PR/0113/22

Record of Executive Business and Chief Executive's Order

Reg. Reference: SD21A/0051 **Application Date:** 03-Mar-2021
Submission Type: Clarification of **Registration Date:** 17-Dec-2021
Additional
Information

Location: Wilsons Auctions, Green Isle Road, Corkagh,
Clondalkin, Dublin 22

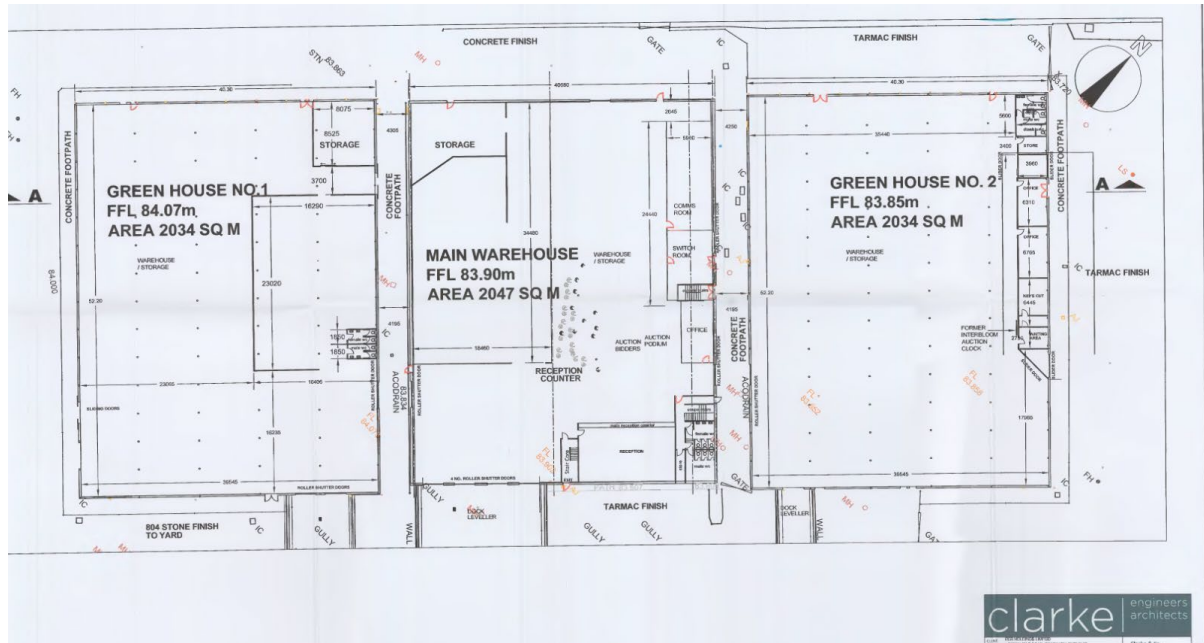
Auctions are ancillary, as confirmed by the limited area of the development devoted to auction uses, i.e. part of the central Main Warehouse as identified on the enclosed ground floor plan (dwg no P05). All remaining internal and external areas are used for the warehousing of products.

The floorplans indicate a small area of the main warehouse dedicated to the auctioneering and has set out that online auctioneering also takes place. In terms of footprint taken up on site, it is apparent that the auctioneering is ancillary to the warehouse / storage use. The times that the auctions take place are also limited and should planning be granted, a condition is recommended restricting the times/number of onsite auctions can take place. The applicant has therefore addressed items (a)(i), (a)(ii), (a)(iii) adequately. In terms of (a) (iv) the applicant has not provided details of concurrent auctions, however, it is noted that there is a single podium and therefore only a single auction can take place at a time. Item (a)(iv) has therefore been addressed adequately. For item (a)(v) the applicant has indicated that there would be any variance of use on days when the auction is taking place verse when there is no auction, as there is no overlap between areas. The information submitted in relation to (a)(vi) regarding Covid is also considered acceptable.
